SERVICE BULLETIN

SUBJECT: CRR, CSR and MAGNUM TXV Replacement

BULLETIN NO: C 058

DATE: January 21, 2003

CRR / CSR with expansion valve and bulb mounted in the condenser section.

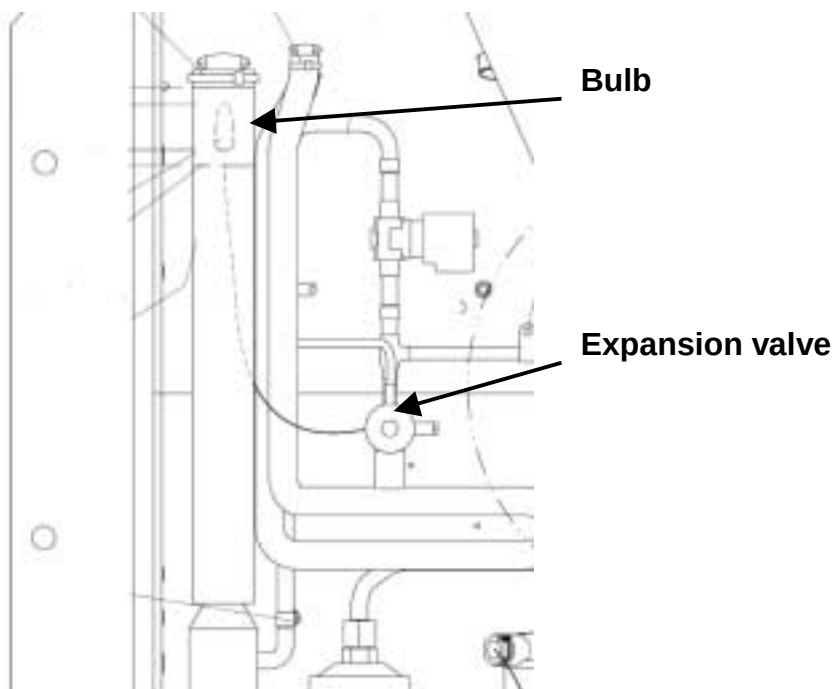
On the CRR and CSR units, the location of the expansion valve and bulb varies. On new units the expansion valve and bulb are mounted in the evaporator section of the unit verses in the condenser section. When ordering a replacement expansion valve, be sure to order the correct valve based on the bulb location.

CRR, CSR and MAGNUM with expansion valve and bulb mounted in the evaporator section.

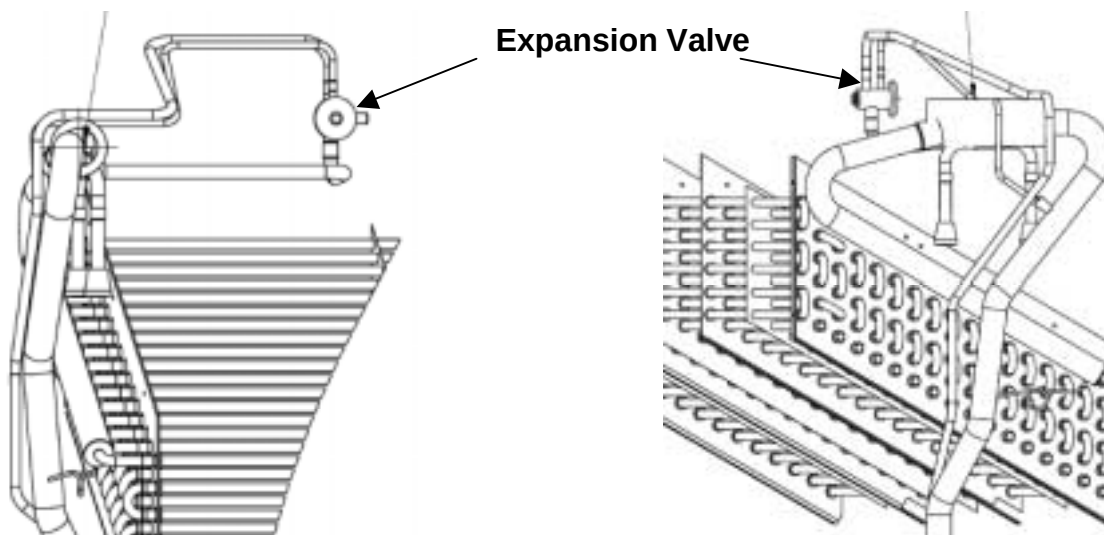
Some CSR units were built with the expansion valve mounted in the condenser section and the bulb mounted in the evaporator section. If the expansion valve needs to be changed and the container is loaded, the bulb can be placed on the suction tube in the condenser section for emergency. After the container is unloaded the bulb needs to be repositioned back in the evaporator section. CSR units with expansion valve and bulb mounted in the condenser section, TK recommends when ordering a replacement valve to order the 61-443 and mount the bulb in the evaporator section. Follow the rework instruction below.

1. Solder in the new valve 61-443.
2. Locate the black plastic plug in the top of the condenser section. Drill a 14 mm (9/16) hole through the plug from the condenser side to the evaporator side. Route the element up through this hole from the condenser side to the evaporator side.
3. From the inside of the container remove the middle access panel.
4. Locate the suction tube on the right side. Clean the tube from just above the caulking to just before the bent in the tube. Mount element bulb on the tube. Secure the bulb with the clamp provided.
5. Cover the element with cork tape.
6. Caulk hole where TXV element was routed through.
7. Reinstall the access panel, using 3/16 alum rivet .450 length (24 per unit)
